MILITARY SPECIFICATION

MODULES, STANDARD ELECTRONIC

FLIP-FLOP, D TYPE, DIGITAL, KEY CODE KDR

This amendment forms a part of *Military Specification MIL-M-28787/61B(EC)*, dated 19 January 1983, and is approved for use by the Space and Naval Warfare Systems Command, Department of the Navy, and is available for use by all Departments and Agencies of the Department of Defense.

FIGURE 22. Threshold clock test circuit waveforms for table XVI.

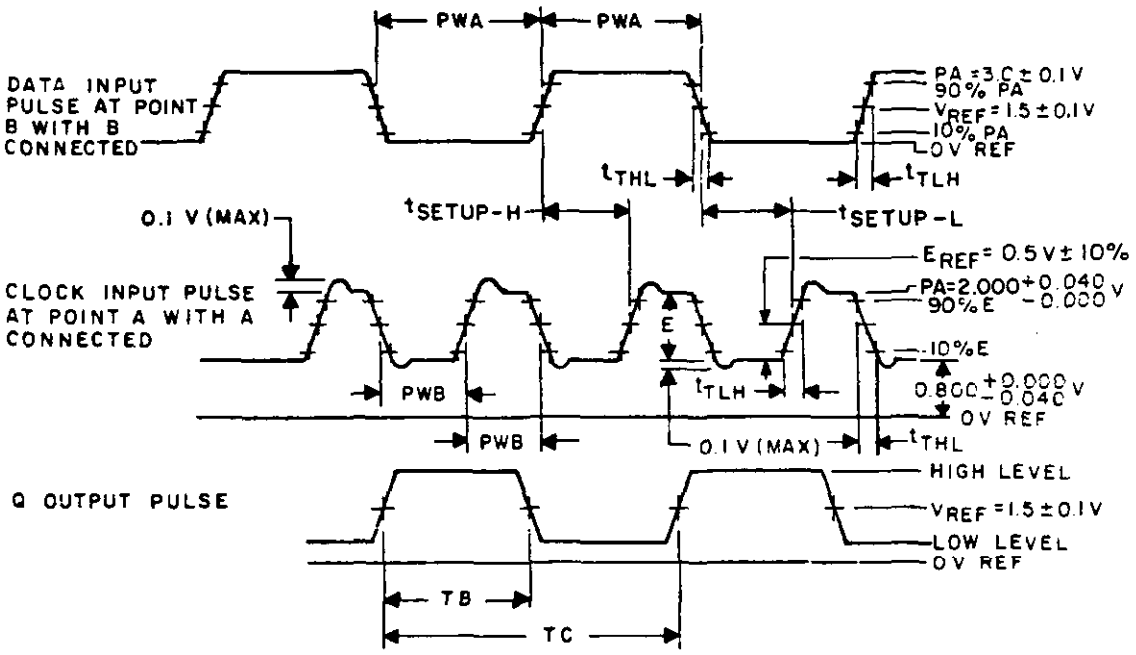
FIGURE 22: Delete and substitute new figure 22 as printed on page 2 of this amendment.

Notes:
1. Input pulse parameters:
   PWA = 500 ns ±10%.
   PWB = 250 ns ±10%.
   $t_{TLH} = t_{THL}$ = 25 ns ±10%.
   $t_{SETUP-H} = t_{SETUP-L}$ = 125 ns ±10%.
2. Both outputs of the circuit under test shall be loaded simultaneously.
3. Parameters TB and TC as measured on item D05 shall comply with electrical requirements of test conditions U1-U6 and shall be measured per waveforms above. Before making these measurements, the output levels shall be verified to be $\leq$ 0.4 V for the low level and $\geq$ 2.4 V for the high level.

FIGURE 28. Power supply transient amplitude test circuit waveforms for table XX.

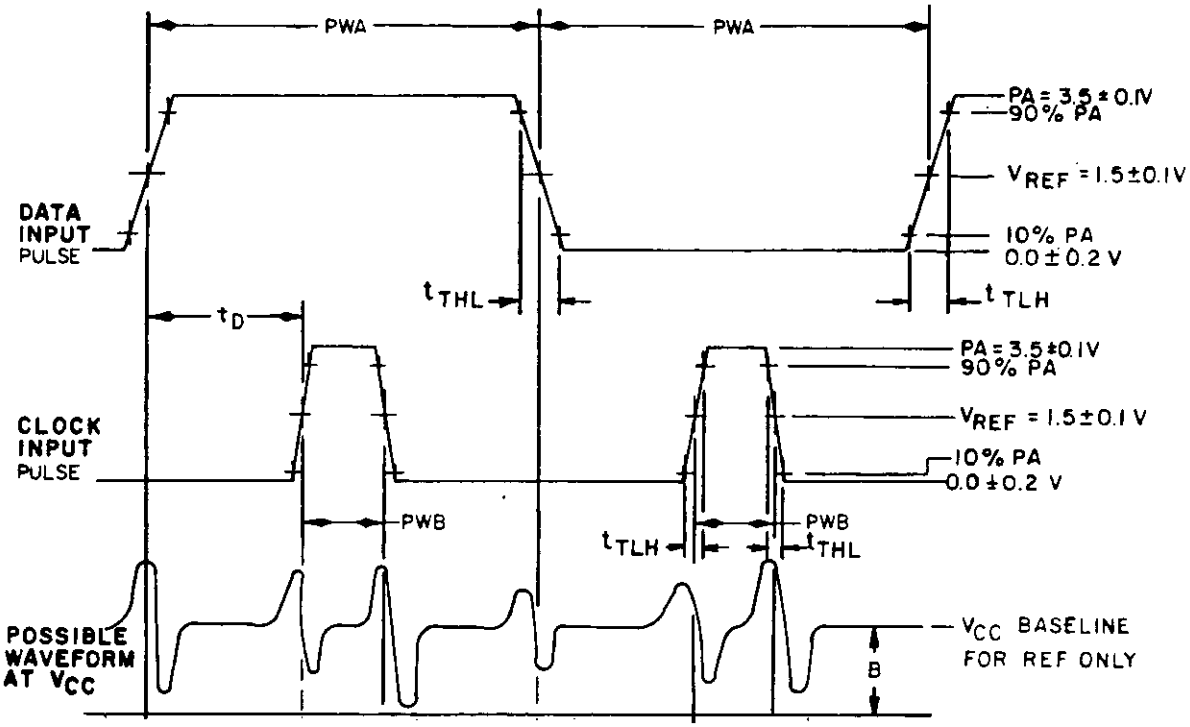
FIGURE 28: Delete and substitute new figure 28 as printed on page 3 of this amendment.

NOTES:
1. Input pulse parameters:
   PWA = 500 ns ±10%.
   PWB = 100 ns ±10%.
   PRR (Clock) = 2 MHz ±10%.
   $t_{TLH} = t_{THL}$ = 10 ±1 ns.
   t_D = 200 ns ±10%.
2. Connect point A as close as possible to pin 1 on the module. Observe power supply transient on item D05; typical waveforms are shown above.
3. B = measurement from the baseline to the most negative excursion of the waveform.
